AirBorne Microlight /Trike Wing Nose Channel Airworthiness Directive

Part 1: Date 21st November 2003: We are currently investigating cracking in the area of the stainless steel nose channel on some Airborne wings. Until we have fully investigated this issue, we recommend that owners/pilots of all Airborne microlight/trike wings inspect the nose channel before flying.

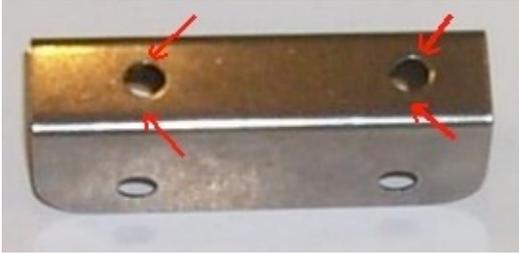
Once the nose channel has been removed check for any cracking around the holes on the back side where the channel attaches to the wing. If any cracking is found do not fly the wing until the part has been replaced.

Part 2: Date 25th November 2003: Our engineers have been studying the reports of cracking that we have received. Analysis and tests have confirmed that this cracking is caused by fatigue due to local stress concentration in the region adjacent to the front mounting bolt. We have simulated, by test, the complete failure of the nose catch in this region. This testing shows that, even if the front bolt hole failed, the rear bolt and the nose catch channel alone are capable of supporting a load of at least 8g.

Part 3 and Final: Date 06th February 2004: We now have a 3 mm guage replacement nose channel available. We also have modified nose pip pins available. Regular inspection of existing nose channels by complete removal or replacement with the new 3mm guage channel is essential. The new channel will allow for easier nose pip pin assembly or removal, simply because of the heavier guage. Once the new channel is installed then inspection as per the maintenance manual is still required.

Carefully inspect the holes on the back side of the nose channel for cracking around the holes themselves.

It is simple to check if your wing has the latest type of nose channel. See the picture below. The new nose channel is made from 3mm thick stainless steel as opposed to the old channel which was made from thinner 0.85mm thick stainless steel. You can use a rule to measure the thickness of your nose channel if you are unsure, or simply ask one of our dealers.
